# **E1200535-v44**

## **TMS WORK TO DO LIST GOING FORWARD**

6-18-2013

**PICTURES OF THE UK AT CALTECH, AND OUR DRAWING NOTE THE GUSSET**

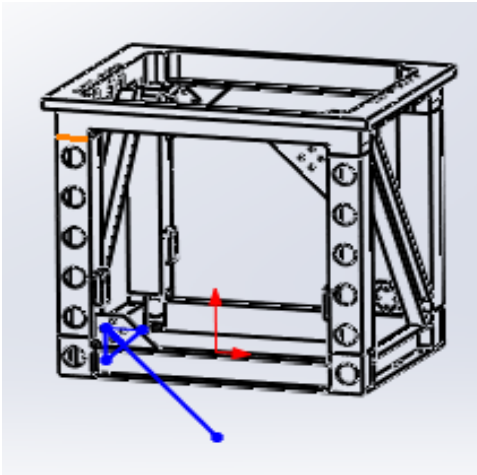
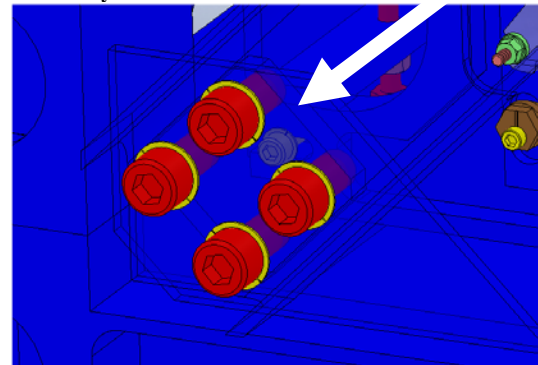
**2. D060492 QUAD WELDED FRAME NEEDS TO BE UPDATED IN THE TMS DRAWING AND ASSEMBLIES TO SHOW THE 'UK' STYLE CONSTRUCTION.**

**THIS CORNER ATTACHMENT FOR THE CHANNEL STIFFENER WELDED IN BRACKET ATTACH POINT (4 PL) RATHER THAN THE NOW SHOWN GUSSET JUST WELDED IN THE CORNER ON THE SURFACE OF THE TUBE.**

**ALSO TO CHECK THE DRAWING FOR THE CHANNEL STIFFENER THAT THE PORT HOLE IS SHOWN FOR THE CONNECTOR CLEARANCE FOR THE BREADBOARD REF. 'UK' PART TD-1084-436**

**ALSO A NEW TOOL FOR ACCESS TO THE BREAD BOARD CAP SCREW OR THE SCREW IS CHANGED TO A HEX HEAD TO EASE ACCESS.**

**ACCESS TO THIS SCREW (SEE NOTE ABOVE) NOT needed anymore**

MATERIAL: 6061-T6 AL  
 FINISH: 63 MILFIN  
 PART NUMBER: D060492

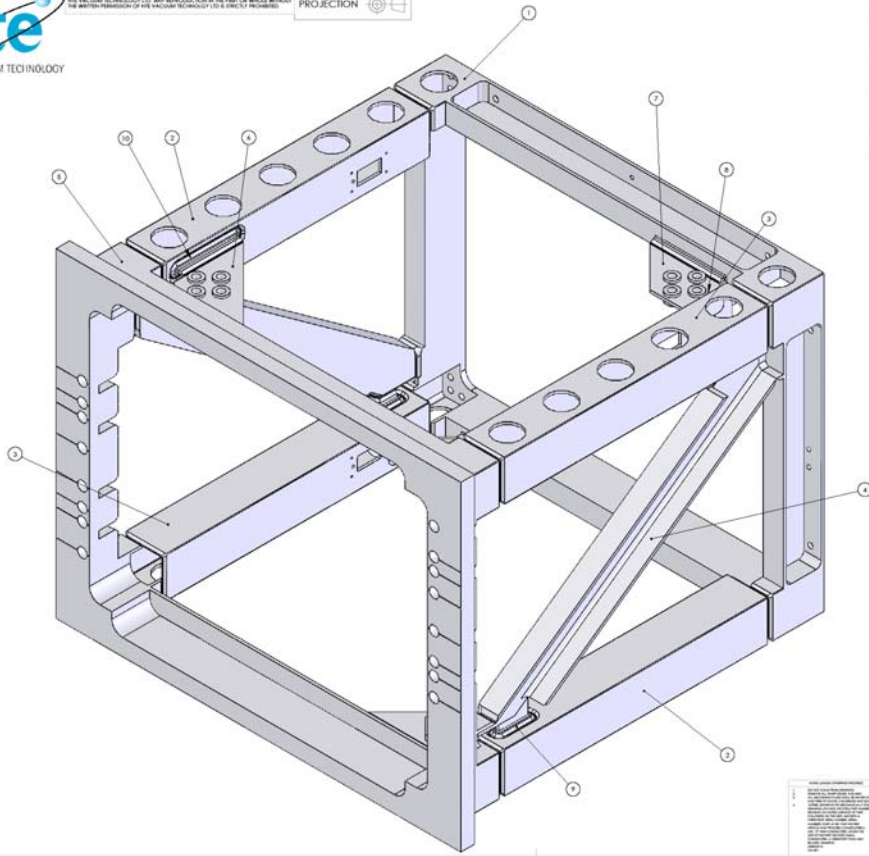
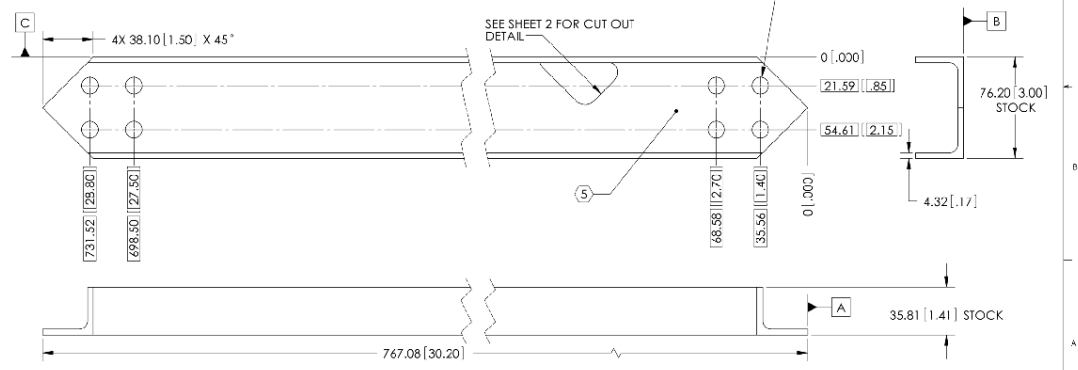
**REF BELOW FOR STIFFENER AND ATTACHMENT GUSSET INFORMATION**

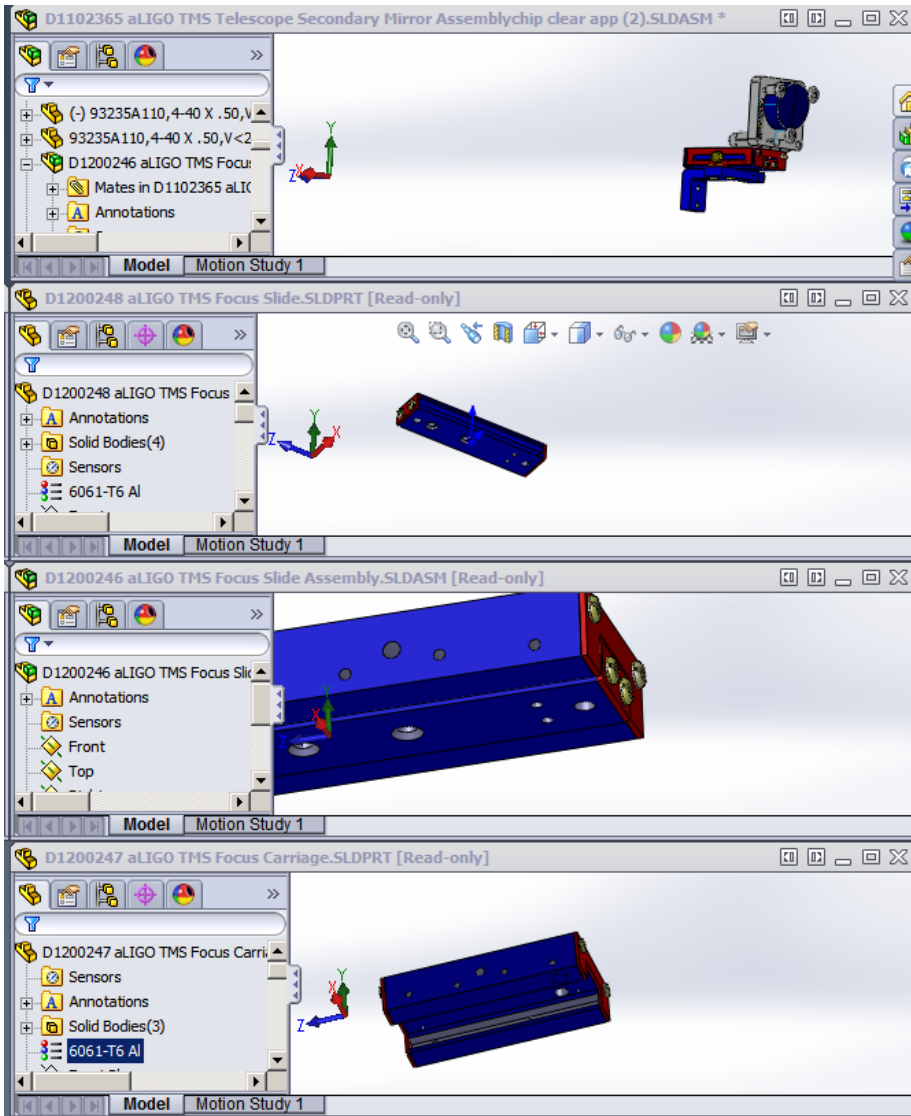
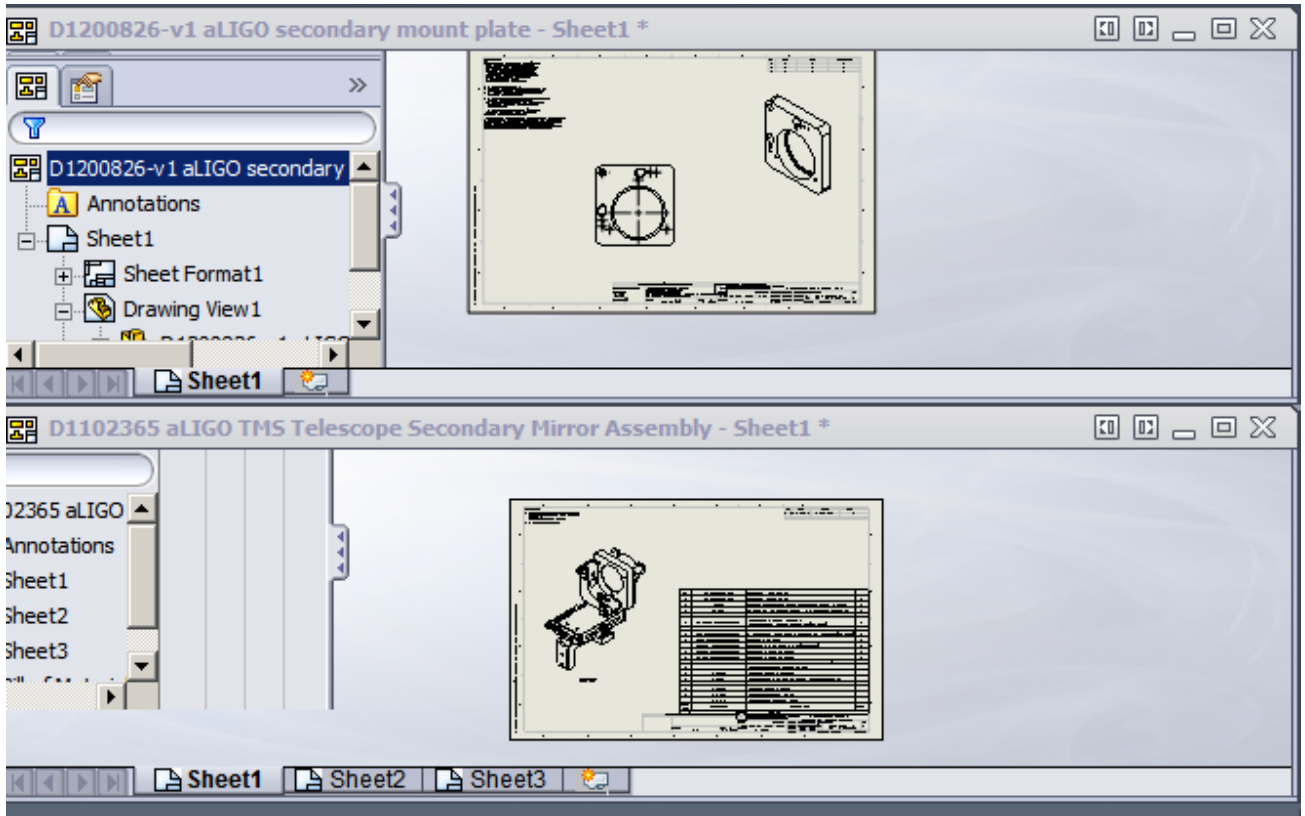
Calum,  
after a good initial cleaning to get the mfg. dirt off,  
last time we wiped it, with alcohol, while it was attached to the door, before we  
attached it to the flanges.

this assembly is really outside, even more than the arm, it never touches anything in vacuum.  
except for the tubes, everything is small, can be put in the sonic bath.

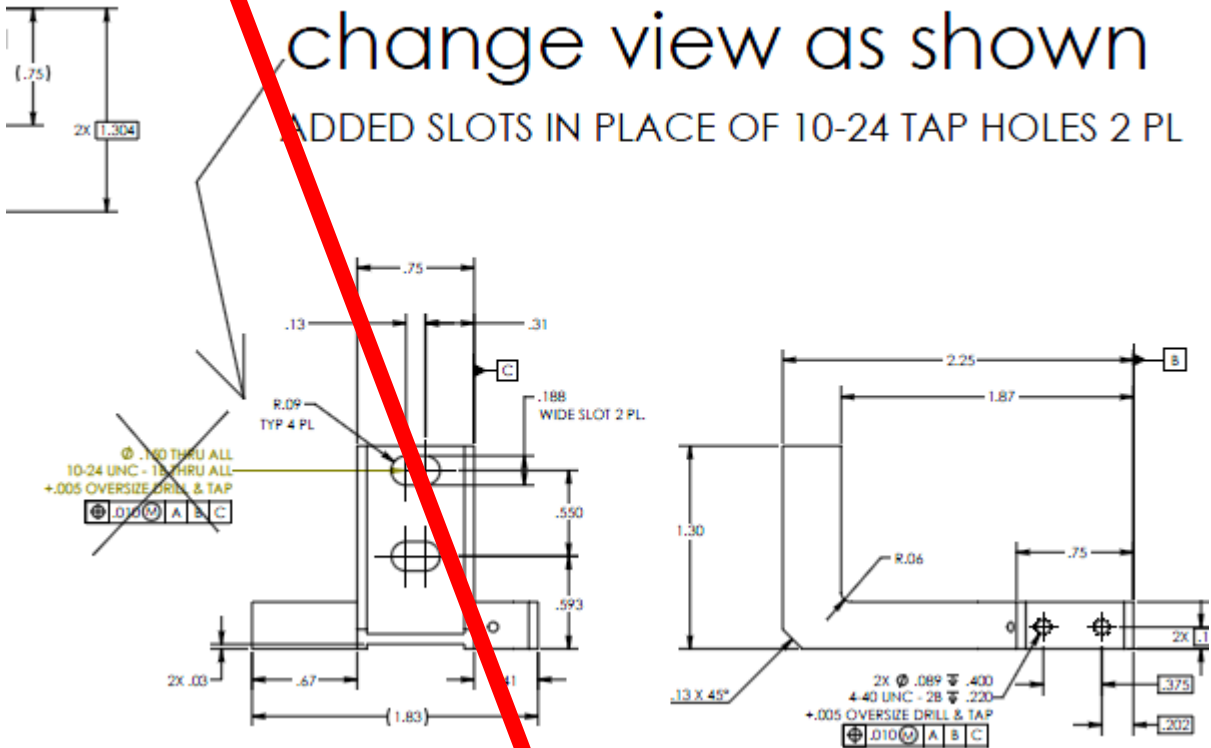
add D1200989 to the proper assembly this is a captive screw for the wire connection for the optical table to the top mass

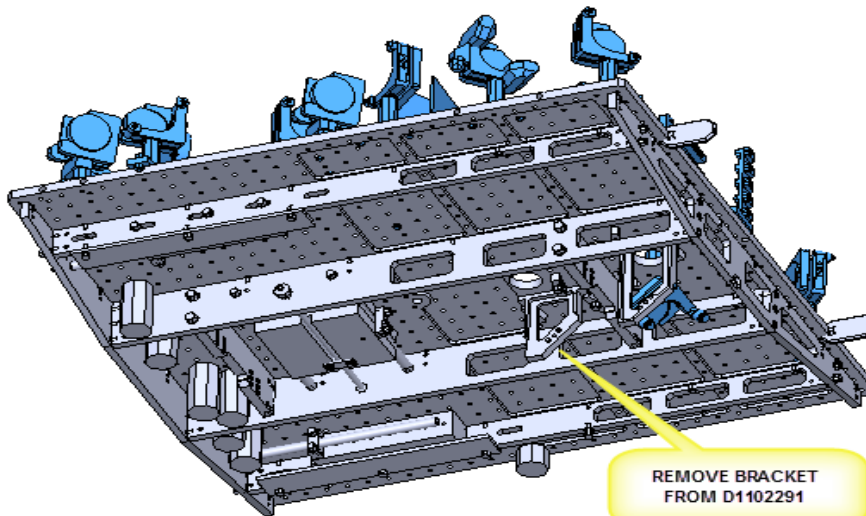
Sam,  
were any parts removed from the top of the ICS table, in comparison to the first article.

i will remove the bracket, and sys. mount, and hardware pointed out below, from the table under side of D1102291

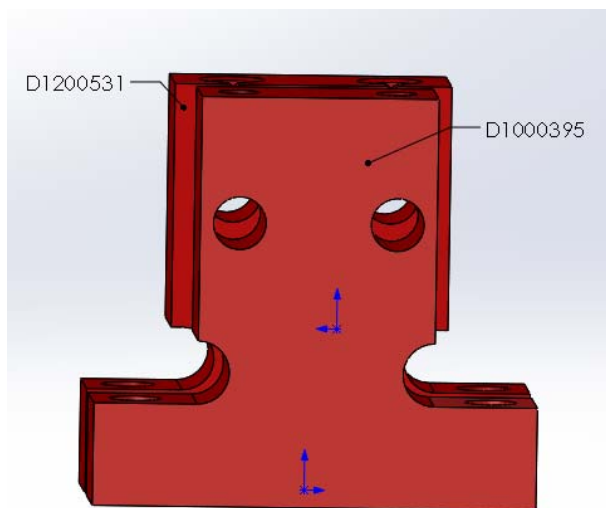
D1100827 item epoxy removed  
D1101487 epoxy removed item 7  
D1101109 transparent glass now is mirror
